TRANSMITTAL

TO: Jennifer Fitch, PE Project Manager Vermont Agency of Transportation	DATE	PROJECT NO.
	8/29/2014	Brookfield BRF FLBR (2)

COPIES	NUMBER	DESCRIPTION	CODE
1		FRP Fabrication NCR 7-2 - PE Seal per 8/22/14 Letter	H

Brookfield BRF FLBR (2)

Figure 1 – Constant Amplitude S-N Fatigue Data[1]

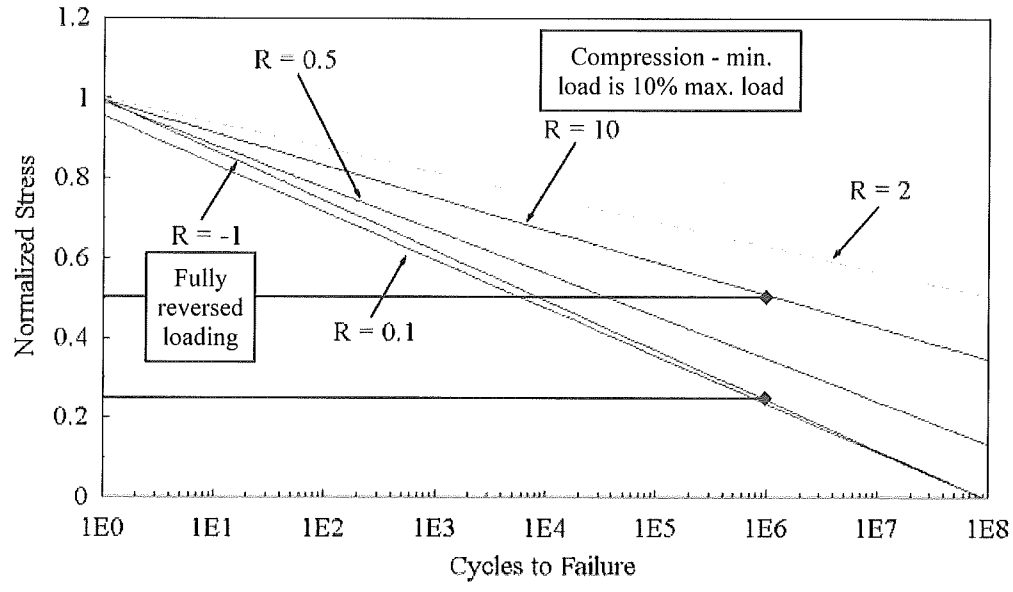
In order to empirically evaluate the long term effect of cyclic loading on the durability of the re-infusion, the direction and magnitude of applicable loads must first be defined. After reviewing the design, Kenway has determined that the quantifiable cyclic loads imparted on the repair areas will be due to ice loading where the load is one sided (compression only) or service loads where the load is fully reversed (tension and compression). Figure 1 shows curve fits to data for vinyl ester infused fiberglass specimens that have been exposed to fatigue loading. This shows that the laminate can be exposed to 50% of its ultimate compressive strength (R = 10) and 25% of its ultimate tensile strength (R = -1) and still reach 1 million cycles before failure. By comparison, the primary laminate in way of defects – completely ignoring the secondary infusion – will see 7% of the ultimate tensile strength and 2% of the ultimate shear strength.

- Quantifiable quasi-static stresses on the primary infused laminate – ignoring the secondary infusion completely – are well below the allowable design strengths as documented above.
- Quantifiable cyclical stresses on the primary laminate – ignoring the secondary infusion completely – and the anticipated number of cycles in service are orders of magnitude lower than documented S-N curves for vinyl ester/fiberglass laminate.
